SHEARON HARRIS NUCLEAR POWER PLANT, UNIT 1
DOCKET NO. 50-400 / RENEWED LICENSE NO. NPF-63

H. B. ROBINSON STEAM ELECTRIC PLANT, UNIT NO. 2
DOCKET NO. 50-261 / RENEWED LICENSE NO. DPR-23

**SUBJECT: TECHNICAL SPECIFICATION CHANGES TO SUPPORT SELF-
PERFORMANCE OF CORE RELOAD DESIGN AND SAFETY ANALYSES**

EVALUATION OF THE PROPOSED CHANGE

Figure 1 – Robinson Maximum Upper MTC Limit Versus Power Level

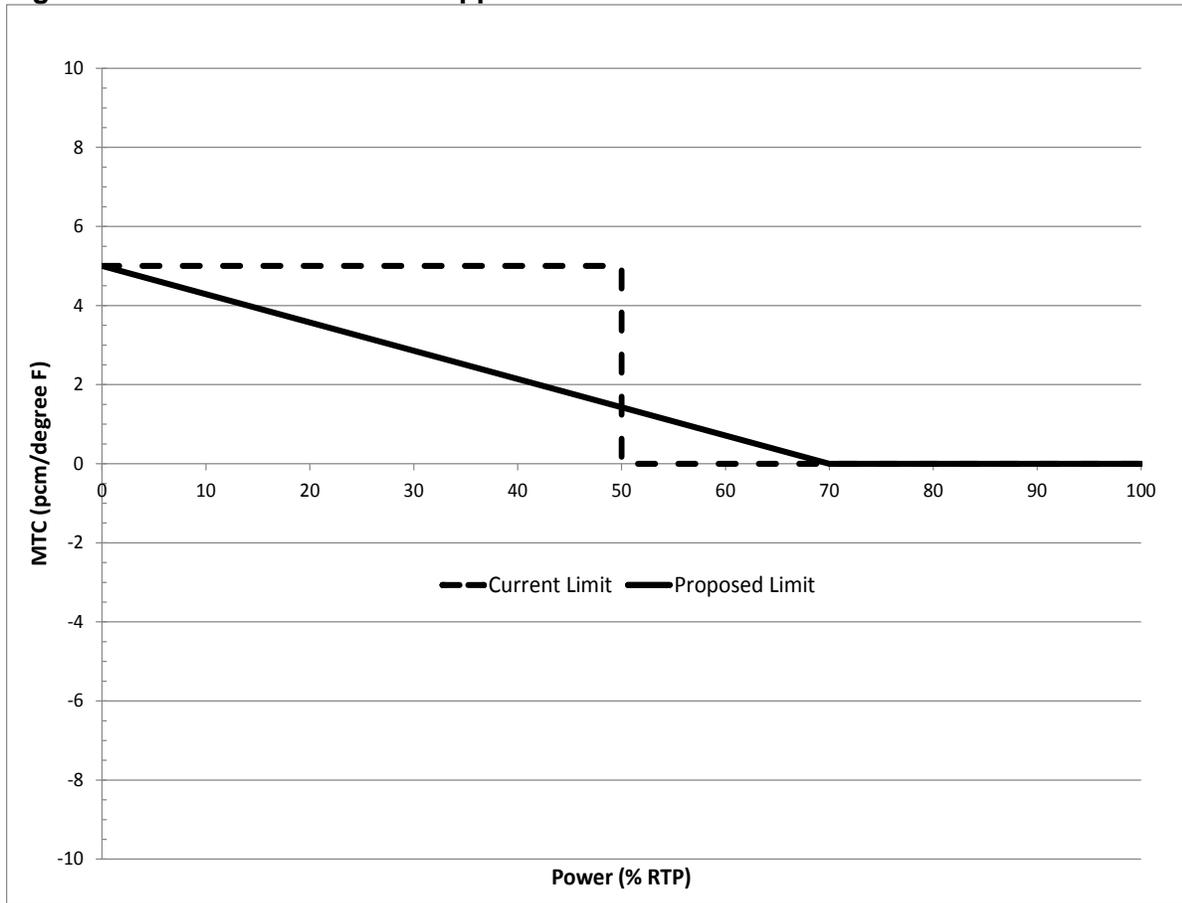
The maximum upper MTC limit in RNP TS 3.1.3 is proposed to be modified to be less than or equal to +5 pcm/°F at hot zero power with a linear ramp to 0 pcm/°F at 70% RTP, or 0.0 pcm/°F at 70% RTP and above. The current and proposed limits are shown graphically in Figure 1. As can be seen, the new limit represents a reduction in the maximum MTC limit at power levels greater than 0% RTP and less than 50% RTP, and a small increase in the maximum limit at powers greater than or equal to 50% RTP and less than 70% RTP.

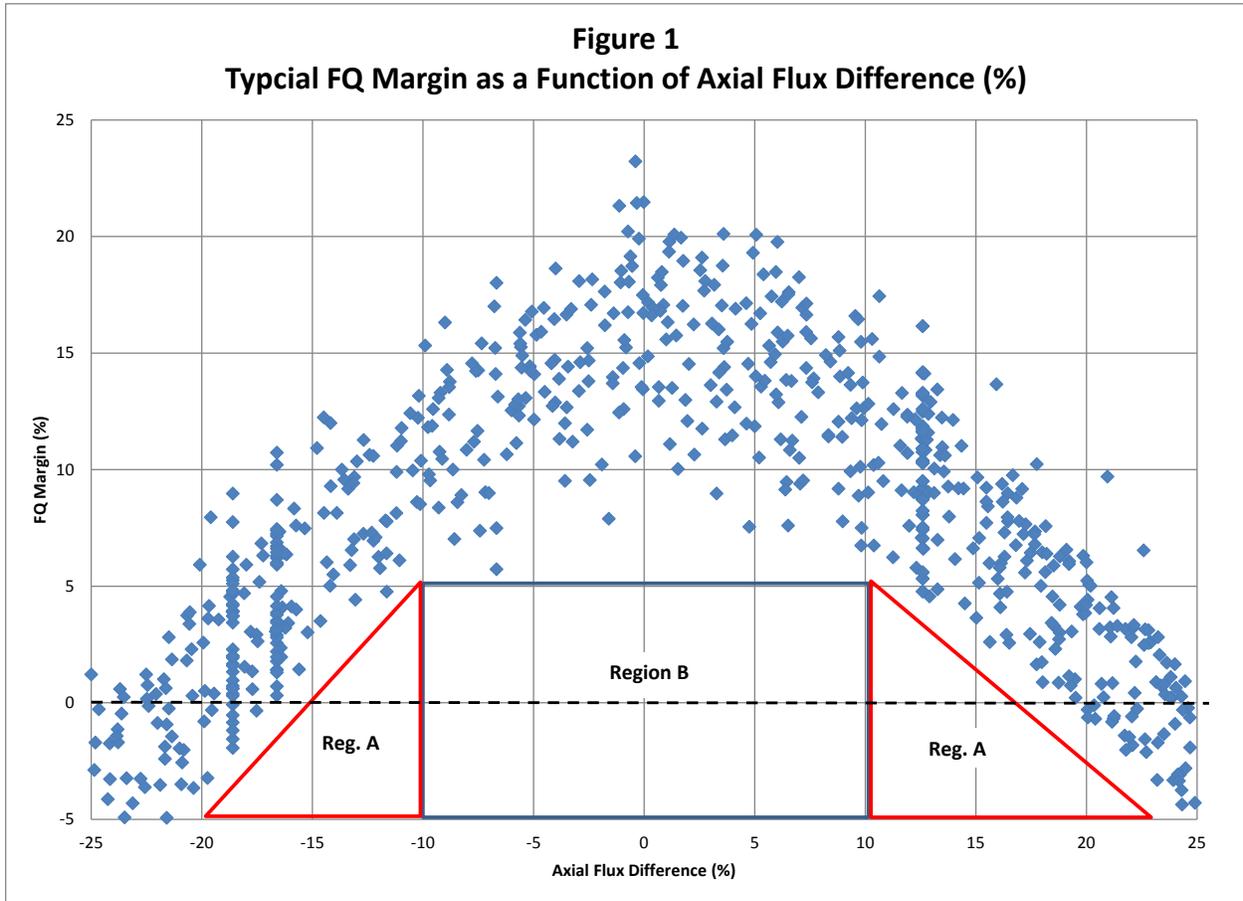
Figure 1 illustrates F_Q margins as a function of AFD and represents typical margins for a 3-loop core. The plot was generated using the core operating limits analysis methodology described in DPC-NE-2011-P. Each point on this plot represents the minimum margin for a particular combination of xenon, control rod position and burnup. The required action to restore the transient F_Q to within its limits are dependent on the magnitude of the negative margin, and corresponding margin improvement required. Region A illustrates a region where a conservative reduction in AFD for a given F_Q margin violation can be determined to restore F_Q

within its limits. However, if the margin improvement required moves into the AFD space defined by Region B, both an AFD and THERMAL POWER reduction would be required to restore F_Q to within its transient limits.

The AFD and THERMAL POWER reductions required to restore the transient F_Q to within its limits are moved from Technical Specifications to a new COLR Table. Relocating these values to the COLR is proposed because the AFD and THERMAL POWER reductions required to compensate for a given negative margin may be influenced by the axial variation in the F_Q limit (i.e. $K(Z)$ penalty), fuel management, and fuel assembly and burnable absorber designs. Consequently, compensatory actions defined in this table will be determined (or validated) on cycle-specific basis using the approved methodology defined in DPC-NE-2011-P listed in TS 5.6.5.b. An example table (Table 1) is shown below. The values in this table are representative reload values.

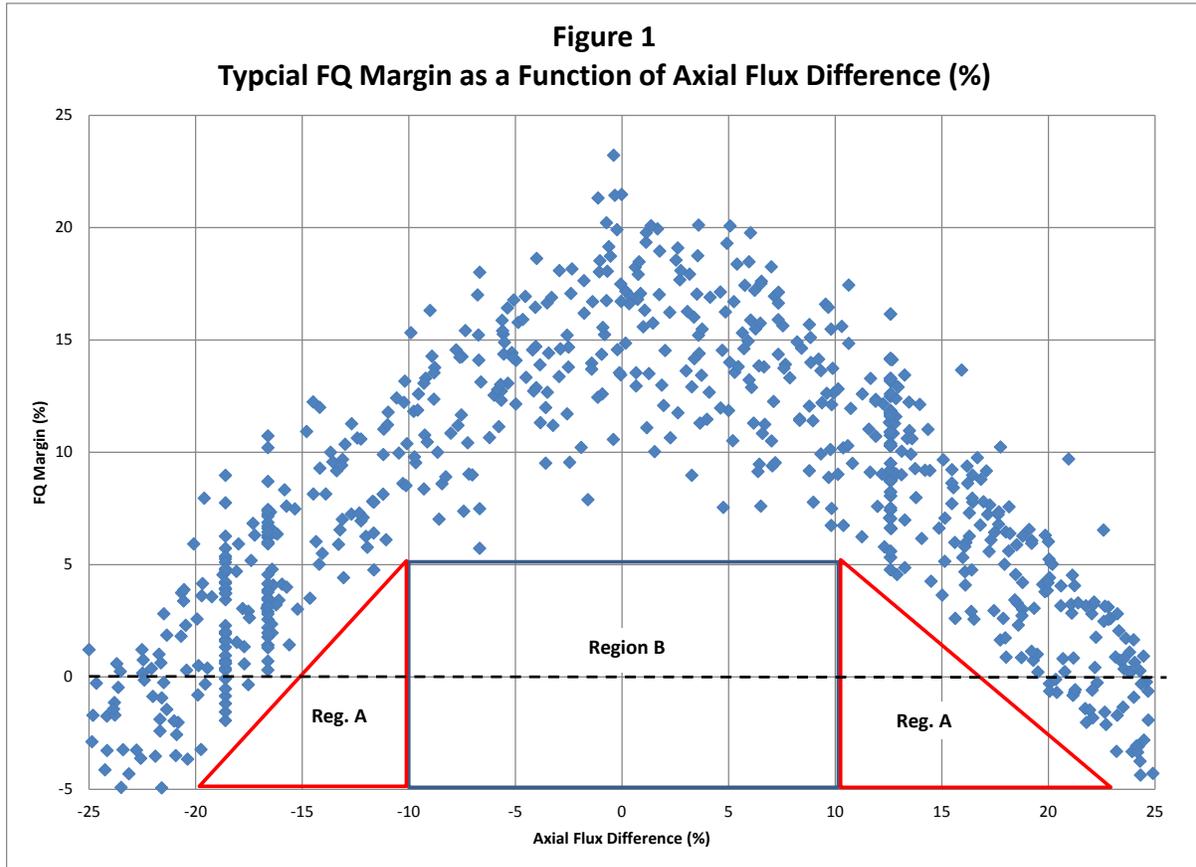
Figure 1 illustrates F_Q margins as a function of AFD. This plot was generated using the core operating limits analysis methodology described in DPC-NE-2011-P. Each point on this plot represents the minimum margin for a particular combination of xenon, control rod position and burnup. The required action to restore the transient F_Q to within its limits are dependent on the magnitude of the negative margin, and corresponding margin improvement required. Region A illustrates a region where a conservative reduction in AFD for a given F_Q margin violation can be determined to restore F_Q within its limits. However, if the margin improvement required moves into the AFD space defined by Region B, both an AFD and thermal power reduction would be required to restore F_Q to within its transient limits.
